**STRUCTURE  
GEOTECHNICAL REPORT  
(Revised)**

Existing SN: 051-0051  
Proposed SN: 051-0065

F. A. S. 1006 (IL 250)  
Over unnamed Stream  
Section 2B-1  
Lawrence County

Subject: Structure Geotechnical Report (SGR) Review

**DESIGN SCOUR ELEVATION TABLE**

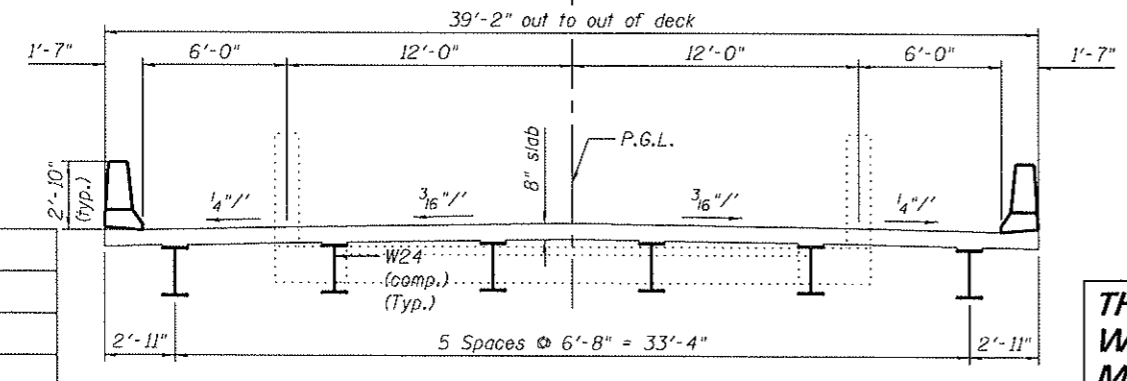
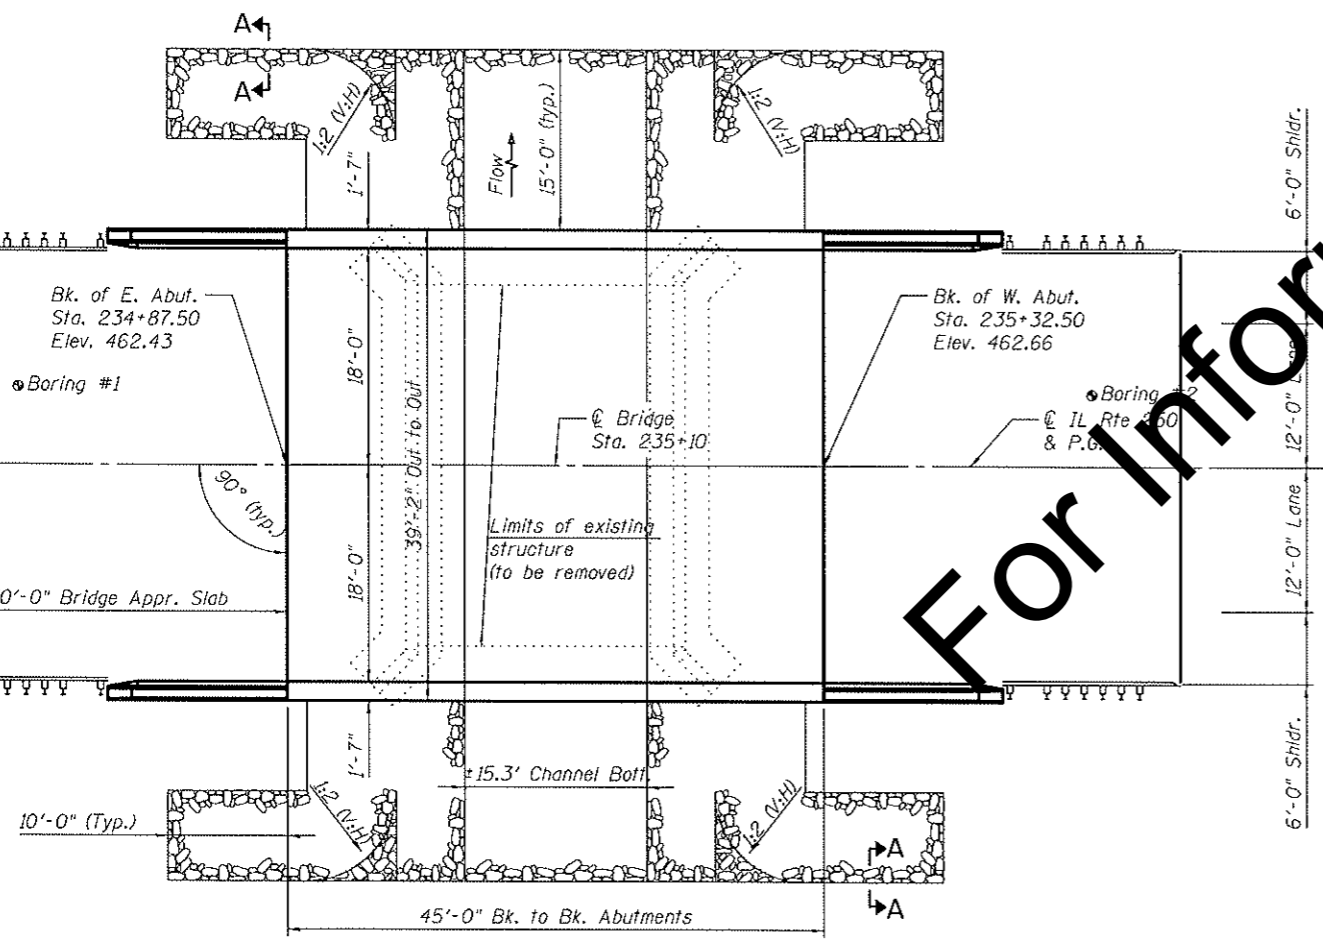
- Estimated settlement times ( $T_{90}$ ) should be provided in the SGR when settlement is expected. If the majority of settlement is expected to take place during construction then this should be stated in the SGR.
- As per ABD 08.3, settlement and bearing capacity should be addressed in the SGR as it pertains to bridge approach pavement. If settlement is expected to adversely affect the approach pavement, or if bearing capacity will be deficient, remedial actions should be discussed in the SGR.
- Estimated loadings used during foundation feasibility assessment should be included in the SGR.
- The Design Scour Table should be changed in the SGR as shown below to reflect the bottom of abutment elevations shown on the TSL.

West Abutment	East Abutment
455.95	455.72
